11.02 Chownes Mead Listed Building - First Floor Plan (NTS)

Current Planning & LBC Application (DM/26/0833 & DM/26/0834)

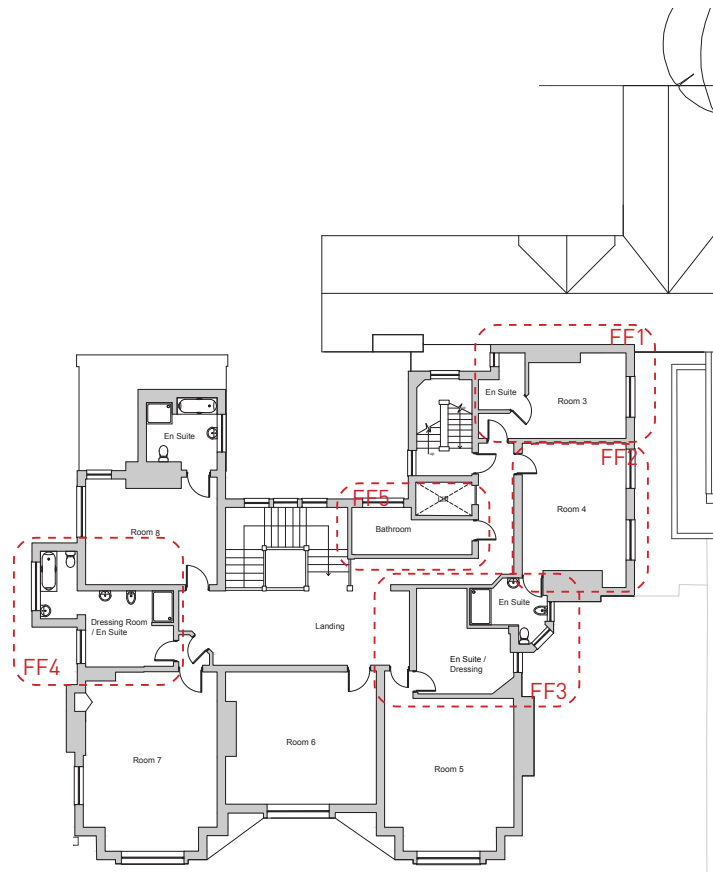
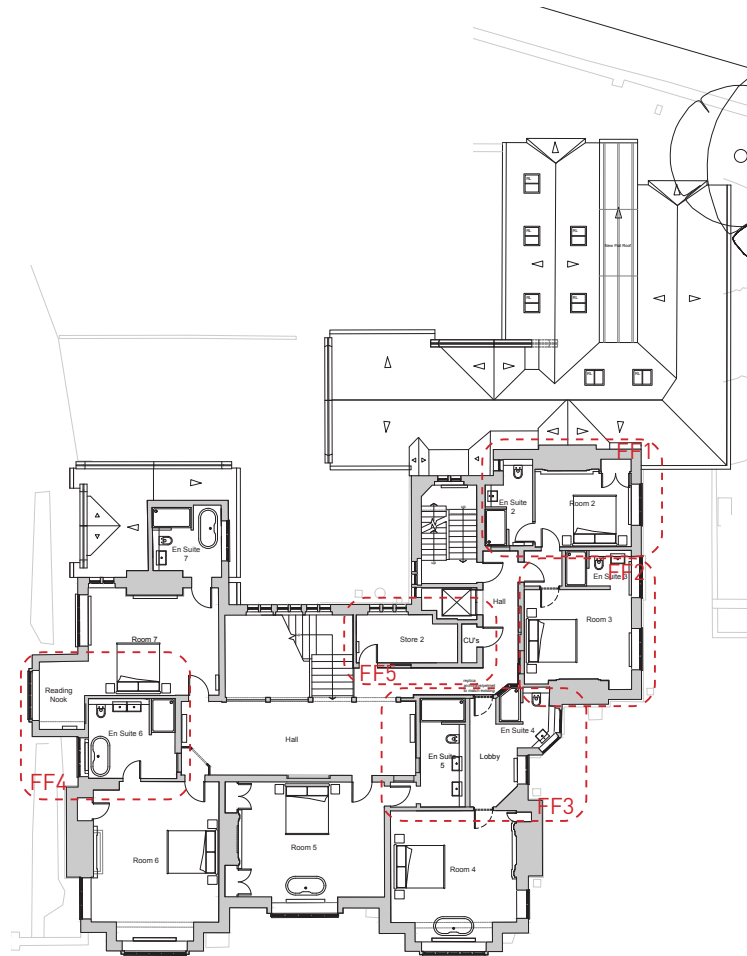
- FF1 En suite to room 2 improved
- FF2 Lobby to room 2 provided and en suite to room 3 repositioned
- FF3 En suites to room 4 reduced in size
New en suite to room 5
- FF4 En suite to room 6 reduced in size
Reading nook provided to room 7
- FF5 Designated as store
